Addendum No. 1
July 9, 2021

Project: Augustana University Softball Field Improvements
Sioux Falls, SD
#2925

Architect: Architecture Incorporated

1) ELECTRICAL DRAWING SHEET 9.10 – SITE PLAN – ELECTRICAL

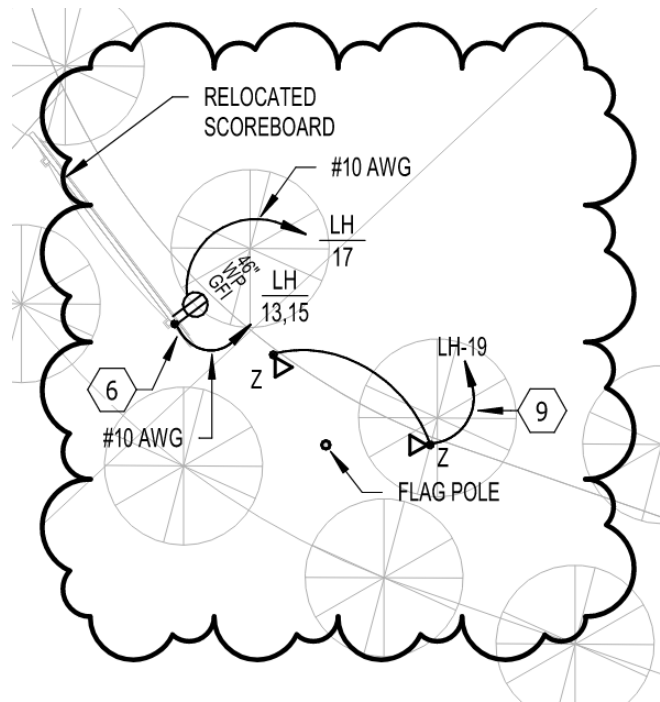
- a) Provide (1) additional type “Z” fixture. See below for location (approximately 10’ setback from light pole).

TYPE "Z" FLAG POLE LIGHT MOUNTING DETAIL

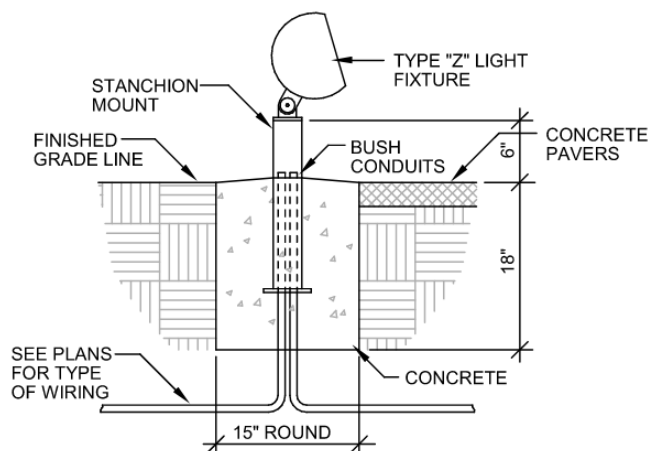
- i. Type “Z” to be equal to NLS CAT#NV-F1 30 16L 45W 40K UNV TM TMS3 STP24 NGC BRZ. Provide fixture base per detail shown below.
